ADDITIONAL DOCUMENT

Answers to Environmental and Social Impact Review Committee questions in the context of the request to amend the certificate of authorization for the Parc National Nibiischii project

Direction des parcs nationaux
December 10, 2020

MINISTÈRE DES FORÊTS, DE LA FAUNE ET DES PARCS

Figure 1 Area difference for the removal of the western sector of the rivière Rupert from the Alouette-Témiscamie-Otish National Park project.

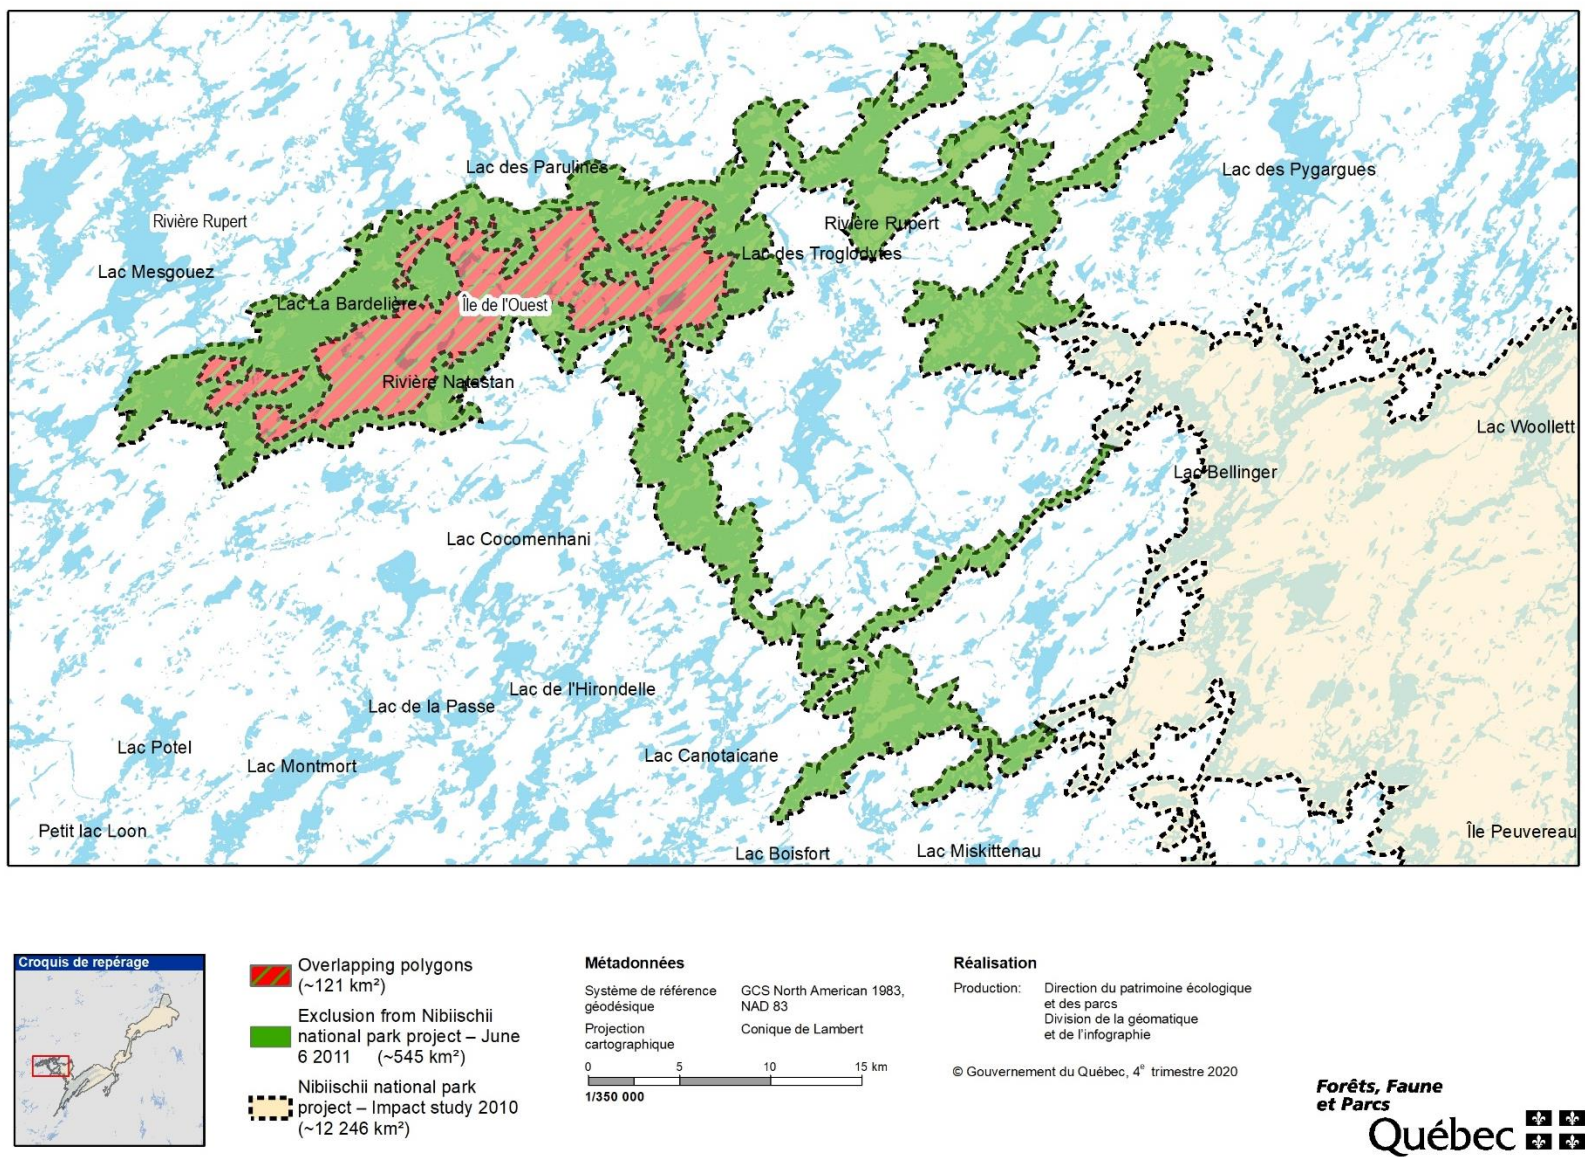
(1) By calculating the additions and exclusions amending the park project's boundaries, 242 km² are missing to reach the total of 11,992 km² proposed in the request. The promoter will have to explain this difference.

Upon verification, it seems that the area to be excluded from the national park project should have been 423 km² instead of 666 km². This difference of 243 km² is due to a geomatic error that occurred while calculating the area to be excluded. In fact, the western sector of the rivière Rupert (Figure 1; green polygon) includes an aquatic portion and a land portion, namely the Île de l'Ouest. However, at that time, the Île de l'Ouest was not part of the national park project. Consequently, it would have been necessary to remove only the area occupied by the aquatic portion, i.e. 423 km². However, in calculating the area to be excluded, the area of the Île de l'Ouest (Figure 1; red polygon with green lines, ~ 121 km²) was not subtracted from the polygon to be removed; it had actually been added. Thus, the national park project area, for which a certificate of authorization was issued in 2011, should have added up to approximately 11,830 km².

Figure 2 Changes to the boundaries of the Parc National Nibiischii project between 2011 and 2013.

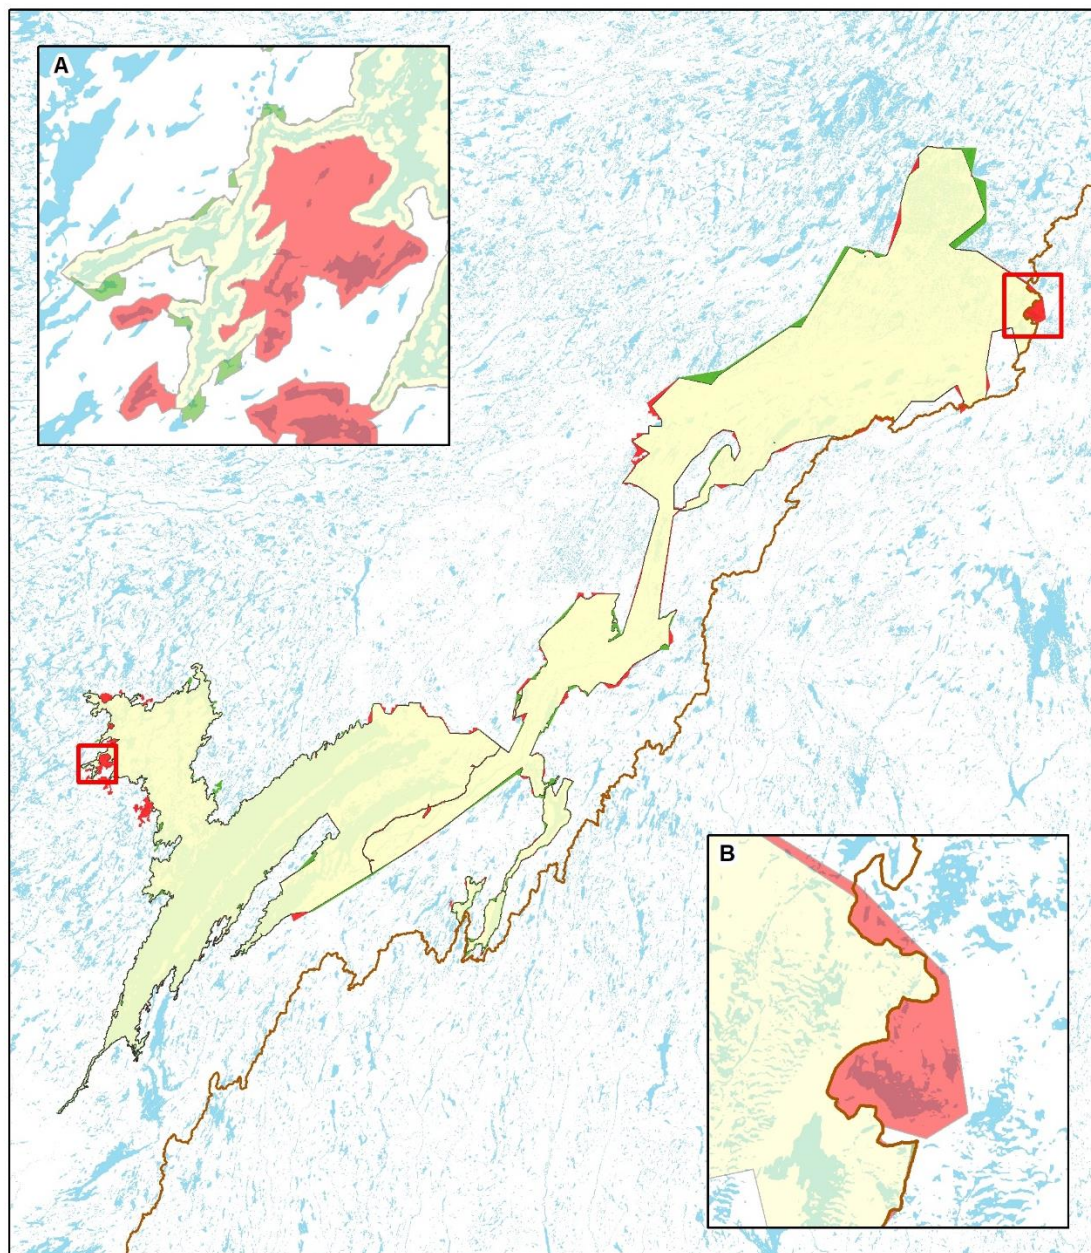
The details that have been provided by the promoter do not allow to target all the proposed additions. The promoter must further detail the difference in park area between the 2011 request and this amendment request. He must provide a map comparing the 2011 boundaries and the proposals in this request.

Figure 2 illustrates the Parc National Nibiischii project boundary changes between 2011, when the certificate of authorization was issued, and 2013. In order to determine a boundary that takes into account the various geographical points that can be identified, the Bureau de l'arpenteur général du Québec (BAGQ) uses a technique that attempts to fit the proposed boundaries. However, since the surveyors must draw straight lines, this technique can add and remove certain parts of the proposed national park territory. In addition, the accuracy of the mapping has been improved from 1/250,000 to 1/50,000. This has clarified the contours of the lakes and rivers and thus changed the boundary, which sometimes includes a buffer zone of 200 m around bodies of water. Figure 2A shows that some bodies of water, once considered part of the western section of the rivière Rupert, are in fact separate lakes that are not part of the proposed national park territory. The southeastern boundary of the national

park project also follows the James Bay and Northern Quebec Agreement (JBNQA) boundary, which subtracts the territories claimed by the Innu Nation (Figure 1B).

Figure 3 Changes to the boundaries of the Parc National Nibiischii project between 2013 and 2020.

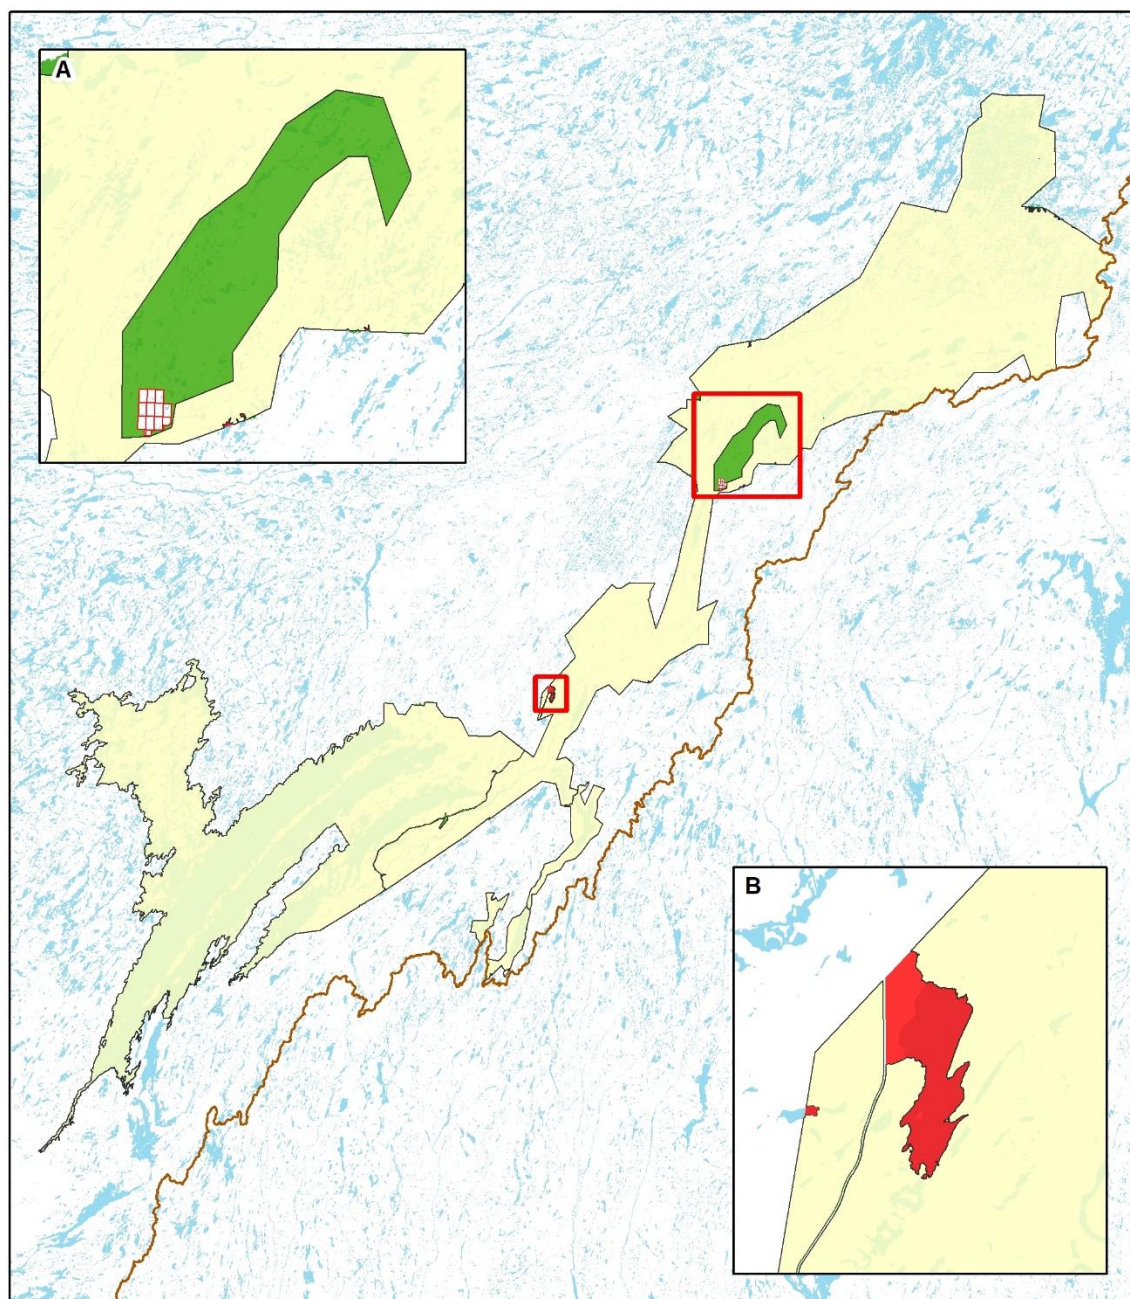
There is a slight difference between the area mentioned on page 11 of the amendment request (11,992 km²) and the one presented in Table 2 of the amendment request (11,989 km²). The promoter must specify the area subject to this request to amend the certificate of authorization.

Following the suspension of the granting of mining claims in the monts Otish sector, an area of 155 km² was added to the park project. Map # 7 of the request shows this area identified by a pink hatch. However, a small area to the south is not hatched, and this suggests that an enclave (donut hole effect) still exists in this area. This area is not identified as having active mining titles.

Figure 3 illustrates the changes to the boundary of the Parc National Nibiischii project between 2013 and 2020. We mainly note the addition of a territory in the upstream part of the rivière Témiscamie (figure 2 A) and the withdrawal of lac Roxane (figure 2B). In addition, four gravel pits were added to the national park territory following their restoration in 2014. Finally, minor adjustments were made to the park boundary to include or exclude certain lakes in order to facilitate the management of the territory.

There were some inaccuracies in the area calculation. Indeed, the area of 11,992 km² includes nine mining claims (total of around 6 km²; Figure 3A) that are still active and are not included in the Parc National Nibiischii project. In addition, the adjustment of Category II land (0.41 km²) and the adjustments related to the preparation of the boundary to send to the BAGQ had not been included (0.58 km²). Thus, the area subject to this request to amend the certificate of authorization is 11,989 km² (NAD 1983 Quebec Lambert coordinate system).

The non-hatched zone area shown on map #7 of the request has not been included in the proposed limit because it contains active mining claims held by SOQUEM inc. (Figure 3A). In the event that these mining claims are not renewed when they expire on April 9, 2021, they are going to be integrated within the boundaries of the national park as specified by condition 4 of the certificate of authorization from December 8, 2011. The process that will then be initiated is basically broken down into the following stages:

Figure 4 Update of zoning in the Albanel campsite sector

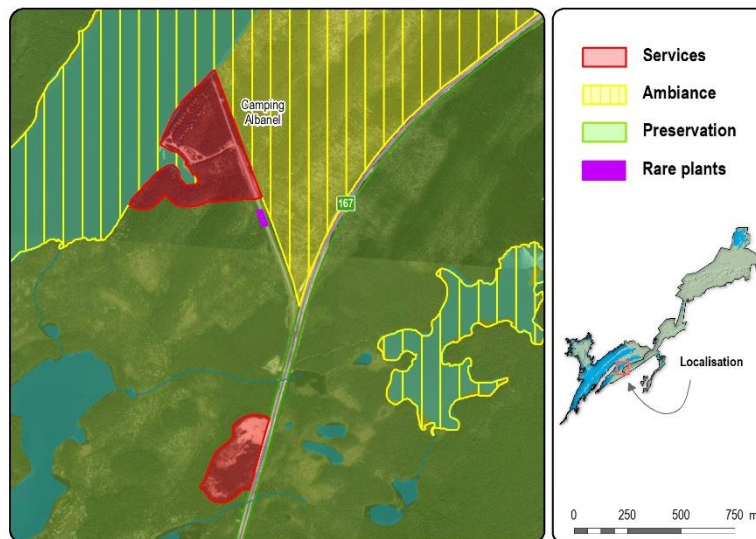
The promoter indicates that there will be an addition of two new zones in the Albanel campsite sector in order to increase the number of spaces available at this campsite, which is full during the summer. On map 14, there are two new service areas in the sector. However, the campsite area is not expanded. The promoter will have to discuss the justification for the two new service areas in this sector. He will also have to clarify why the current service area is not being expanded.

There are false mountain willows (*Salix pseudomonticola* C.R. Ball) along the access path to the Albanel campsite. However, no mention is made of the presence of a plantation of false mountain willows in the smaller of the two service zones along route 167 north. It should be noted that this plantation is a mitigation measure that was required by the ministère des Transports du Québec (MTQ), as part of the route 167 North construction project. Moreover, the latter monitors the growth of the plantation in connection with the mitigation measure. In this regard, the MTQ conducted a field inspection on July 31, 2019, which led to an update of the protection limits for false mountain willows. The promoter must indicate the type of development he plans to carry out in this sector's service area. It must also indicate how the plantation of false mountain willows will be protected and how it will take into account the protection limits identified by the MTQ.

There was an error in map 14. The text does refer to an expansion of the south side of the campsite, but the map does not reflect this change. The following map illustrates the proposed zoning change. As a result of this addition, the service area of the Albanel campsite increases from 0.11 km² to 0.26 km².

No development is currently planned in this area (see Figure 4). In the area to the south, a remote landfill (reference number 3214-16-078) has been established. Waste and generator oil are being stored there temporarily. The MFFP intends to apply the recommendations of the firm that carried out the inventory in 2018, namely to fence the transplant site and report the presence of this plant species with special status (see report in Appendix 2).
